SEABROOK STATION

SBN-357

Subject: Draft SER Section 3.5.2

In response to the above comments, we have revised FSAR Sections 6.4.2.2 and 9.4.1.2 to include tornado-missile protection for the Control Room air intakes.

FIG. 6.4-1

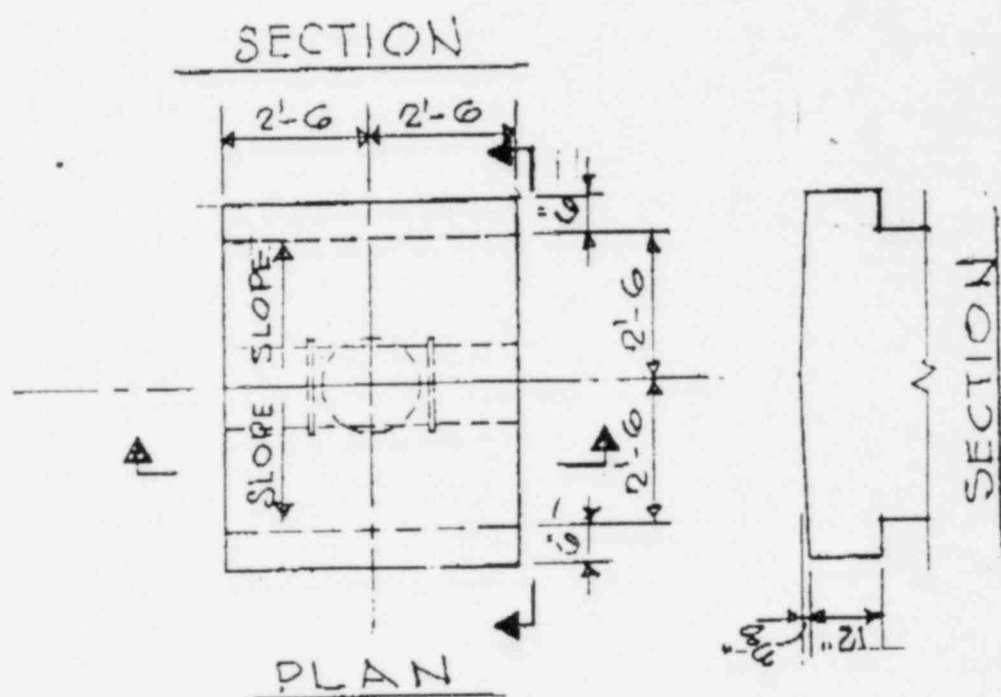
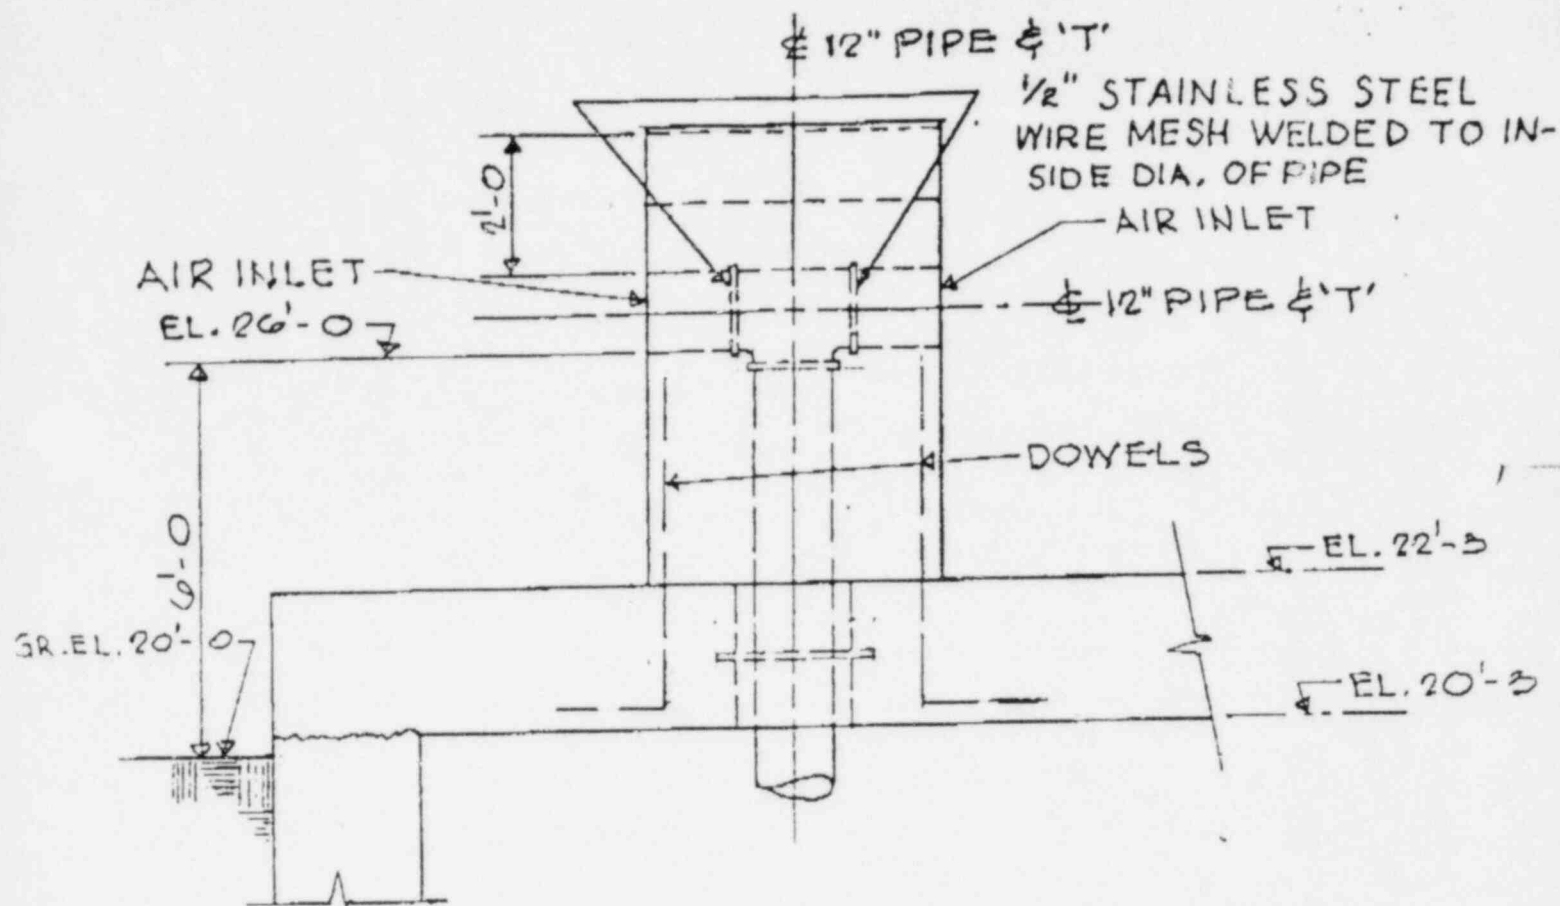
FSAR Section 3.5.2 indicates that all safety-related systems and components including outside air intakes and exhausts in safety-related structures and stored fuel are located within tornado-missile-protected structures or are provided with tornado-missile barriers or other protection or are oriented such that tornado missiles do not present a safety hazard. However, FSAR Section 6.4 indicates that the Control Room intakes are not protected from tornado missiles (see SER Section 9.1.4). We require that the applicant clarify this discrepancy.

Each of the air intakes consists of a vertical 12-inch diameter carbon steel pipe terminating in a tee-section to allow air to enter the pipe from two directions. Both openings are protected by 1/2-inch square stainless steel wire mesh welded to the inside diameter at both openings. Protection of the intakes against tornado missiles is provided by a reinforced concrete structure with a 2-foot thick overhanging reinforced concrete slab (see Figure 6.4-1). The structure is surrounded on four sides and top by a cyclone-type fence,

45
Each of the air intakes is protected against tornado missiles by a reinforced concrete structure (see Figure 6.4-1)
